3411 FAIRPLAY

SITE PLAN

COVER SHEET

DATE : 03/01/2022

EXTERIOR ELEVATIONS

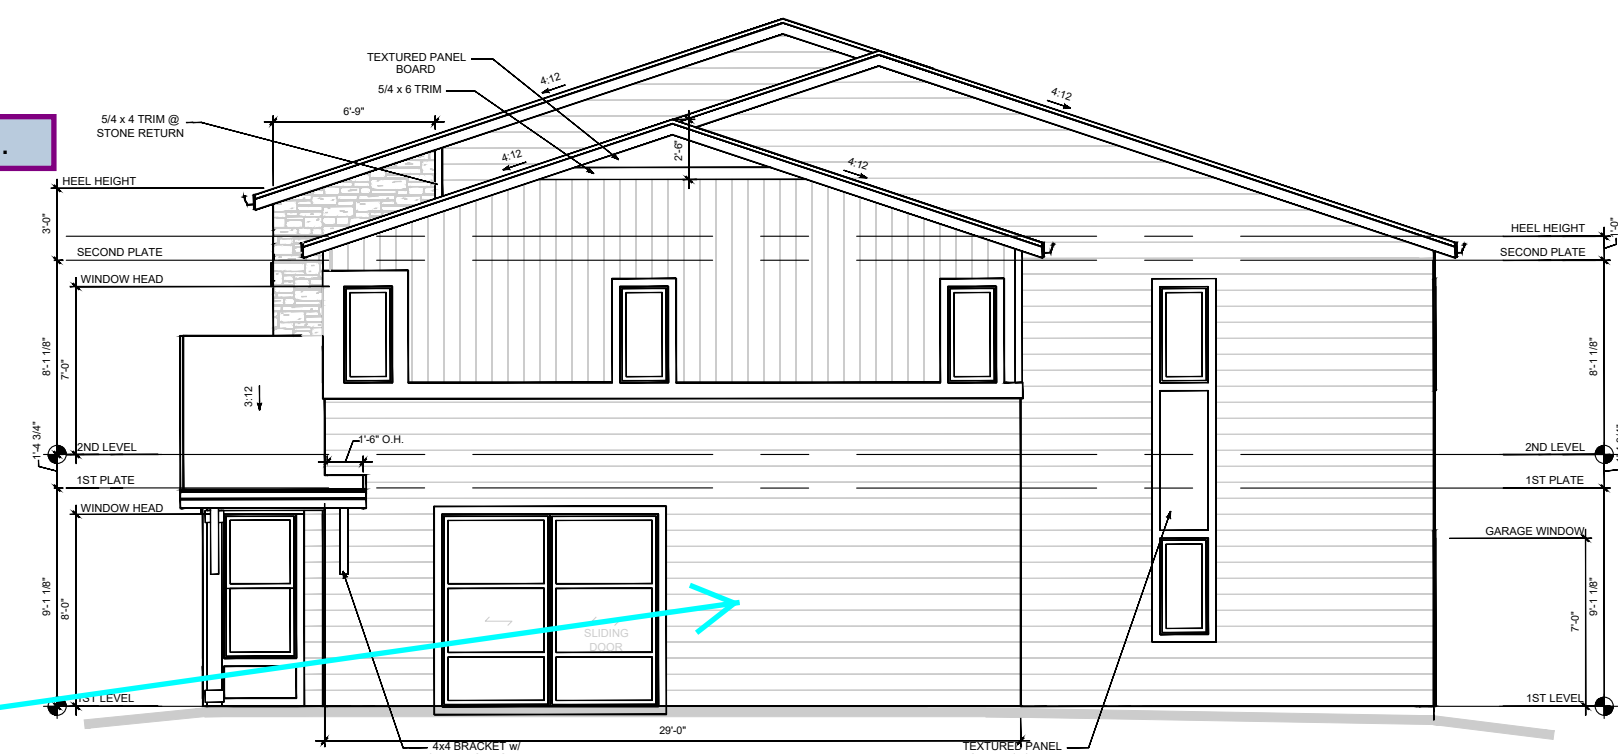
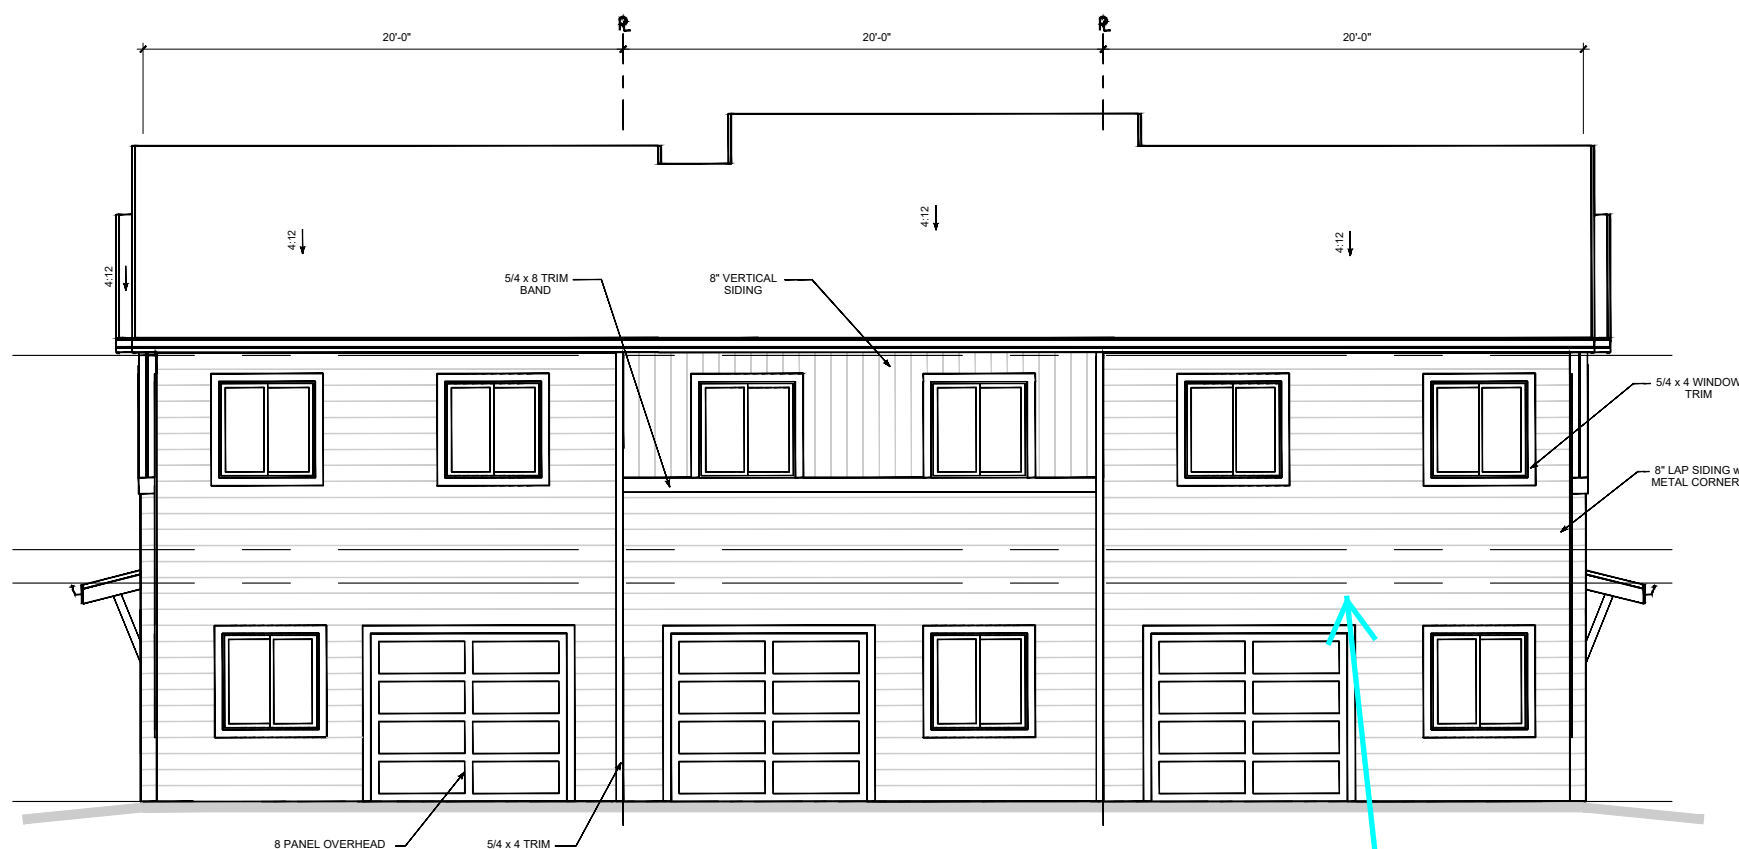
2015 IRC. The City has recently adopted the 2021 I-codes, which can be used but not required until later this year.

Needs additional visual interest per the UDO standards, 4-sided architecture.

Show these as directional. i.e. North side, south side, west side and east side.

This needs more visual interest. See development standard language.

REVISED AS REQUESTED.

REVISED AS REQUESTED.

REVISED AS REQUESTED.
